From: Patti Bonham [pbonham@pratthomes.ca]
Sent: Tuesday, May 03, 2011 9:44 AM
To: 'Bruno Tidd'
Subject: SWD-6-Doane New Deal

SCHEDULE "A" MODEL AND FLOOR PLAN

lot 6
Southwoods

Southwoods
1180sf
AD

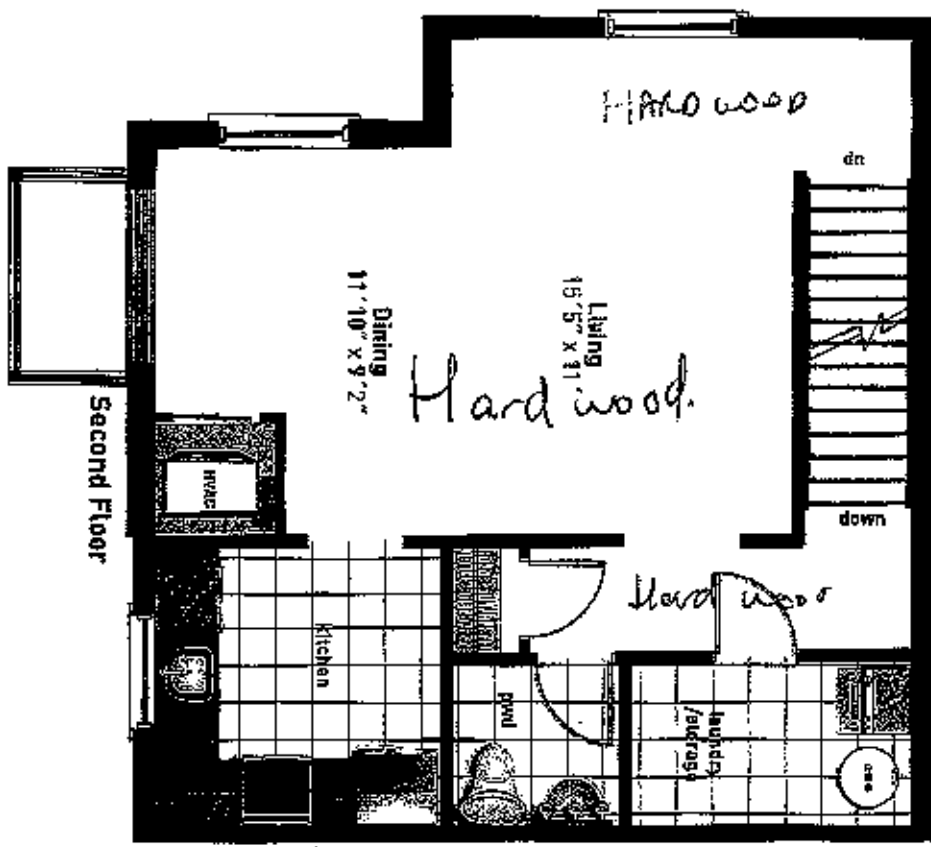
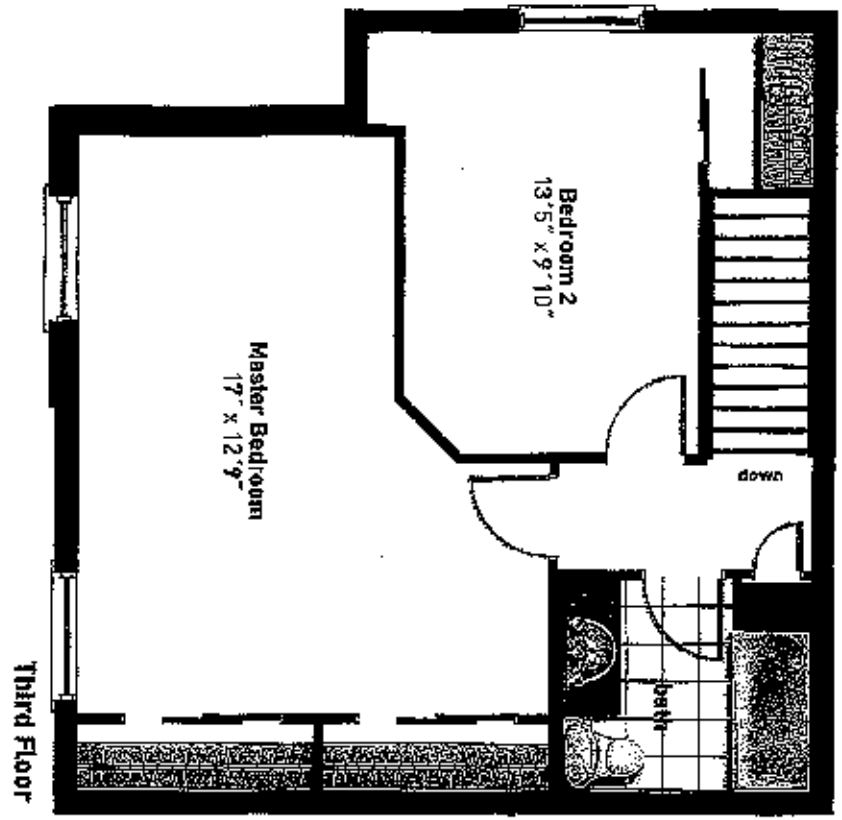
The work sheet and sched c both show hardwood flrg as shown in diag.
There is nothing written on the fir plan. Should there be?
